**EB-2023-0261 Neustadt Community Expansion Project Leave to Construct
Pollution Probe Interrogatories to the Applicant**

**Enbridge Gas Inc.
Neustadt Community Expansion Project
Leave to Construct**

POLLUTION PROBE INTERROGATORIES

Figure 1: Energy Savings (percentage) for a ccASHP compared to natural gas, oil and baseboard electric.

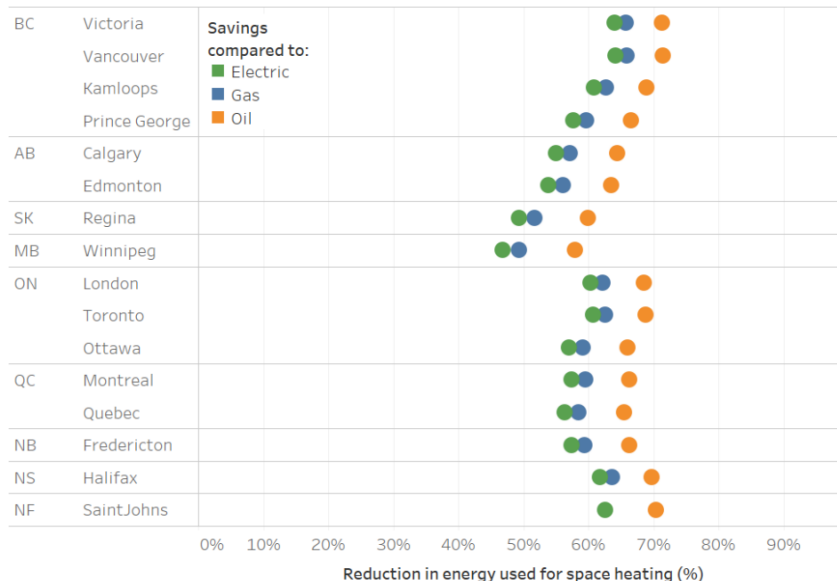
The CanmetENERGY cold-climate air source heat pump (ccASHP) Report filed by Enbridge indicates in Figure 1 (above), that for Ontario jurisdictions a ccASHP is approximately 50% to 70% more efficient than natural gas, oil or resistance (i.e. baseboard) electric.

- Please indicate whether this information for ccASHPs was shared with potential customers as part of the information related to heat pumps. If it was, please provide a copy of the information/materials provided to consumers.
- This information was provided by Enbridge in 2023 based on a 2022 Study. If Enbridge has a more recent/relevant study/information that provides a different savings rate for ccASHPs vs. natural gas, oil or electric resistance heating, please provide a copy.

3-PP-11

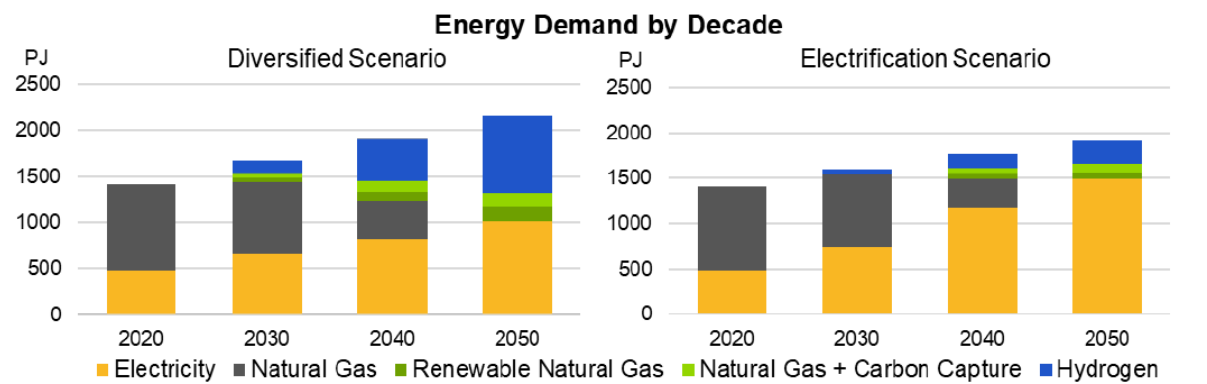
Has Enbridge conducted a risk assessment on the probability that the proposed pipeline will become a stranded asset before being fully depreciated? If yes, please provide a copy of the assessment and all related materials. If no, what evidence exists to support that the pipeline will remain used and useful for the full amortization period.
